# Rechannelization of Noname Brook

Waterford, Connecticut

REPORT

**Review Date:** AUGUST 15, 1985

SURFICIAL GEOLOGY

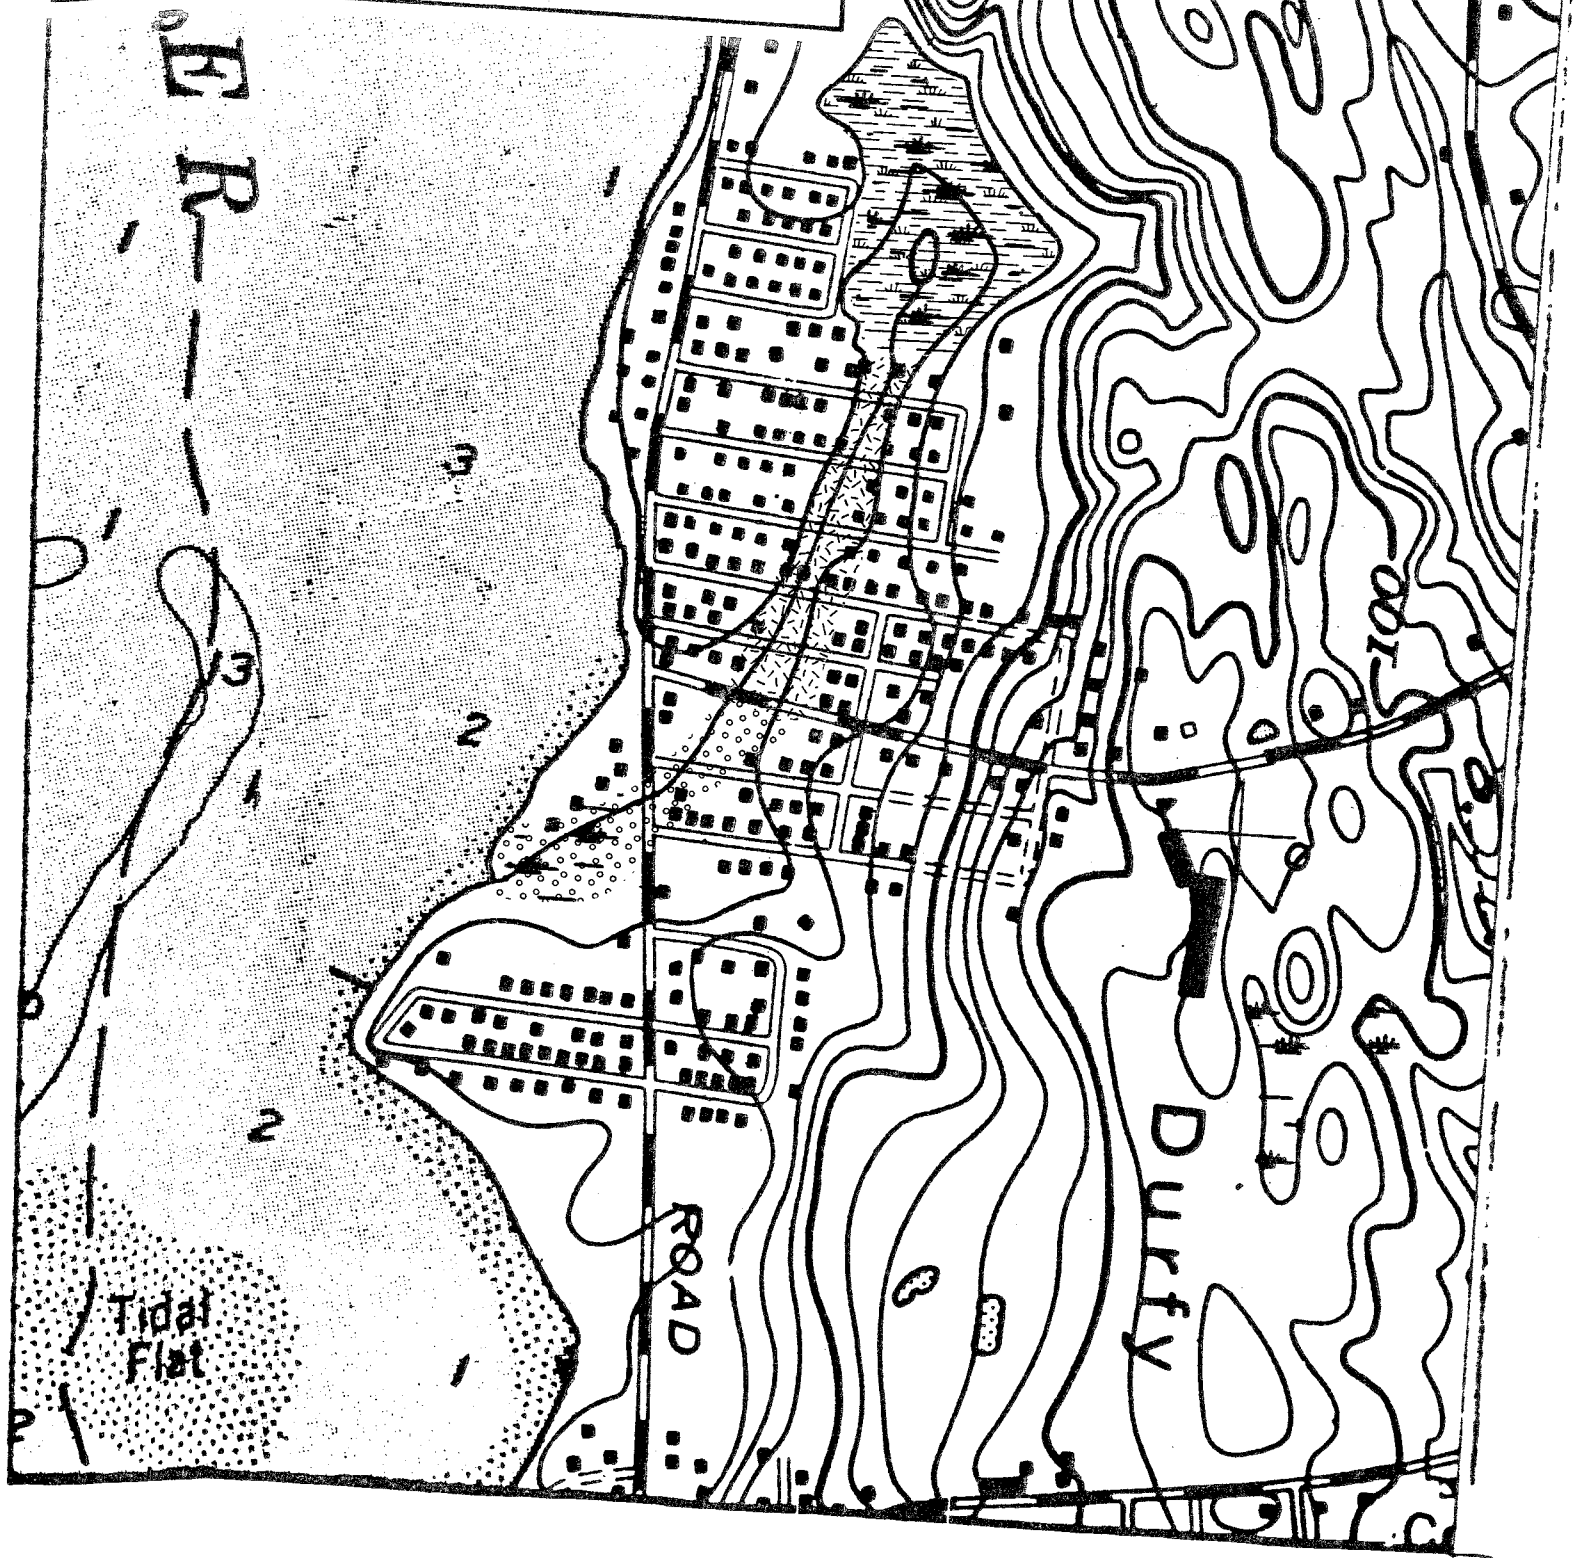
Present plans indicate that a section of the tidal wetlands between Second Street and Daniel Avenue would be filled in order to better define the brook's channel. According to the application, it will consist of a seven foot trapezoidal base riprapped channel. Approximately 790 cubic yards of "quality satisfactory" fill material is estimated for the filling operation. As mentioned earlier in the report, this portion of the brook is comprised of tidal wetland soils which contain organic material. The exact thickness of the organic material in this area is unknown. Provisions should probably be made to determine the thickness of organic material and to remove all unstable material in this area before placing any fill material.

The proposed rechannelization project and upgrading of Noname Brook should be done during the dry time of the year and should include provisions of effective erosion and sediment control.

WETLAND AREA  
DESCRIPTION LOCATIONS

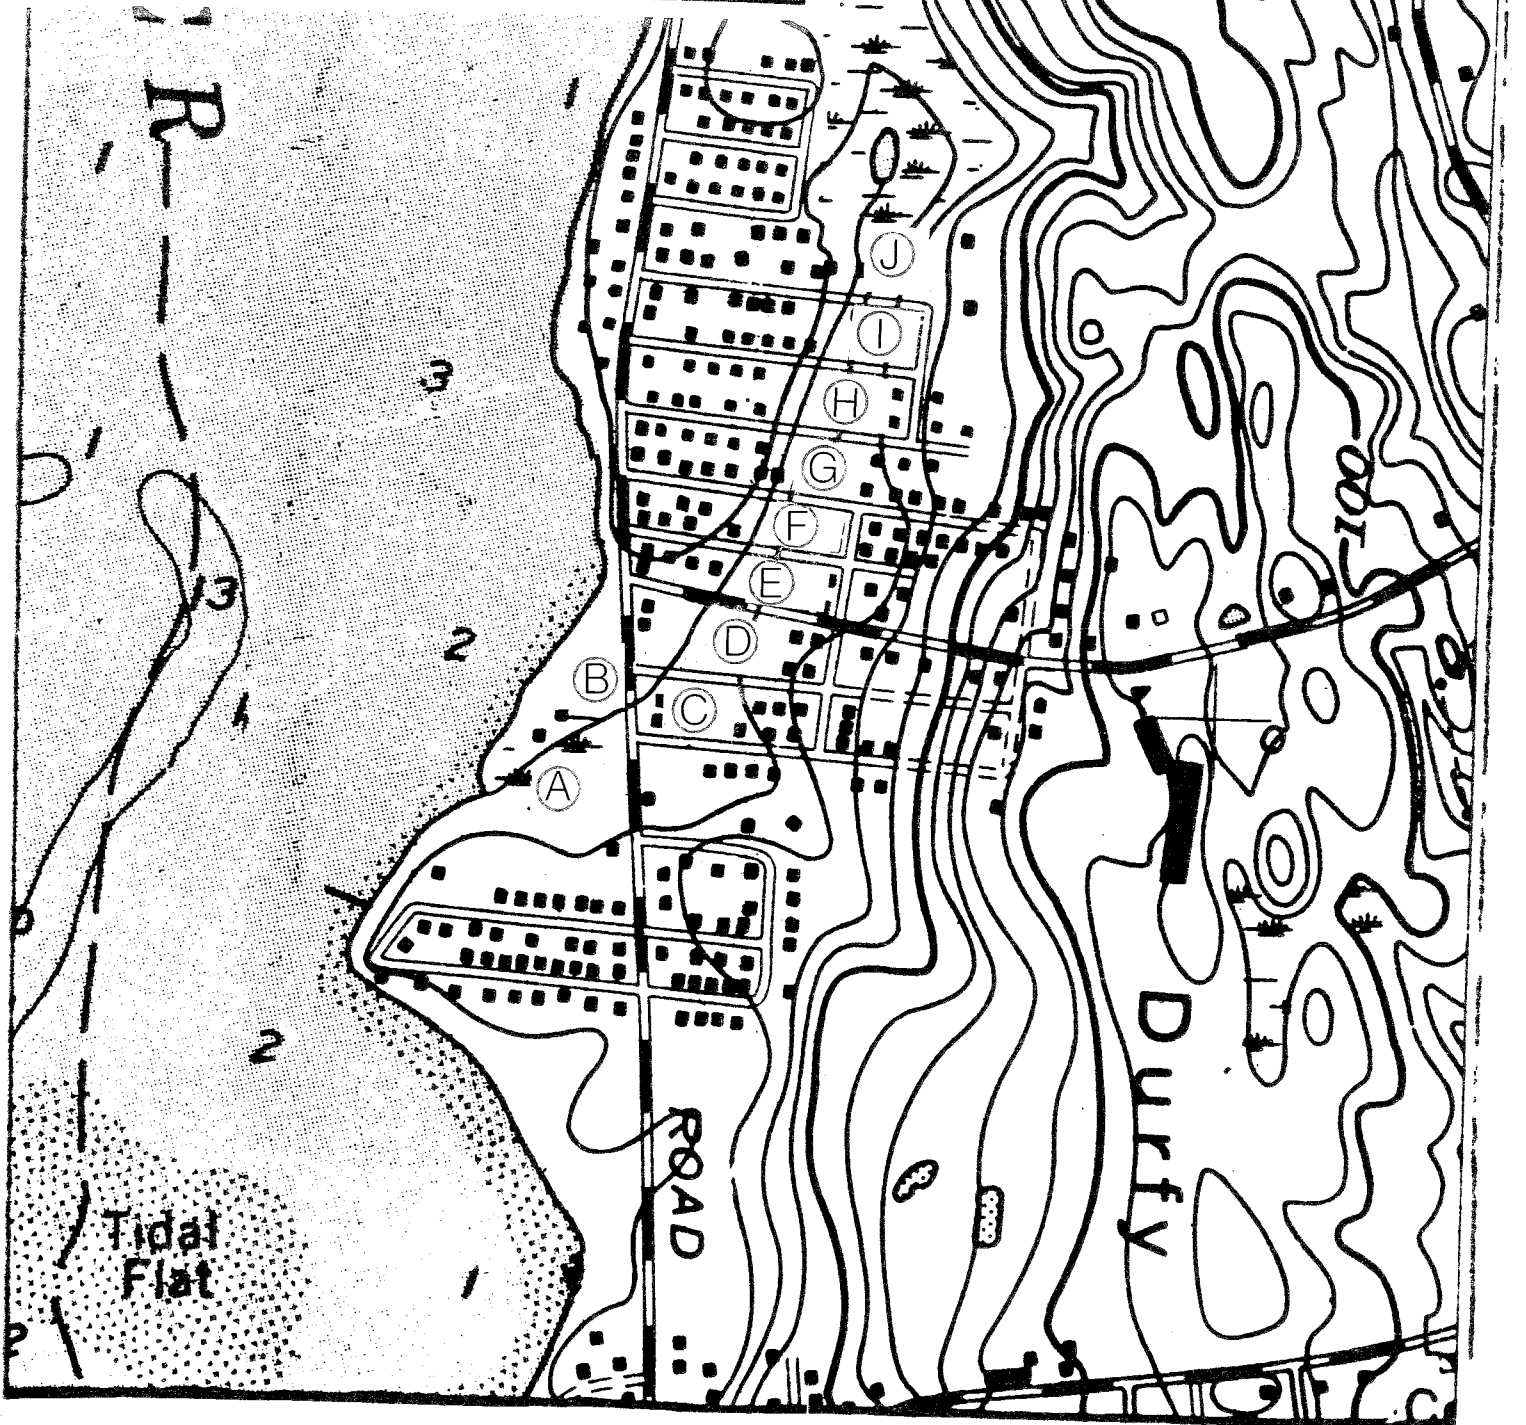
The project proposal for area D includes excavation of a channel, lining the channel with riprap and placement of inorganic fill over the mucky peat. The CSPR application should contain an explanation of why filling is necessary. Filling may be consistent with the tidal wetland policies if it can be demonstrated that filling is necessary and that no alternatives exist. Also, if wetland restoration is possible in this area, the finished grades of the fill should be sufficiently low to allow for regular tidal flooding so that the site can continue to support wetland plants.

If placement of fill to either side of the channel is necessary and if wetland restoration is possible, then the finished grades of the fill should be established at elevations between local spring high water and mean sea level. At this time, it is not possible to determine the feasibility of wetland restoration until the tidal information for area D is generated and the elevations of the top of the finished channel are known. This information needs to be generated prior to completion of the CSPR application and any necessary state or federal permit applications. The Office of Planning and Coordination/Coastal Management is available to assist the town in determining the feasibility of wetland restoration in this area.

The feasibility of marsh restoration can be determined by recording the level of high tide in area D and area C adjacent to the Niantic River Road culvert during a neap and spring tide. This simply requires the observation of the slack high tide level for these two events and relating these tidal levels to a known datum. This information should then be noted on the plans. Also, a few spot elevations should be established at several points on the mudflat and the adjacent zone of Reed. Slack high water occurs when the waters in the culvert under Niantic River Road and Second Avenue are slack. Slack high water in Noname Brook may occur up to two hours after predicted slack high water in the nearby Long Island Sound.

The proposed plan should be reviewed to determine if the new stormwater flow rates will cause scouring of tidal wetland in area A and B. If tidal wetland destruction will occur because of scouring then a mitigation technique should be incorporated into the design to eliminate or minimize this adverse impact.
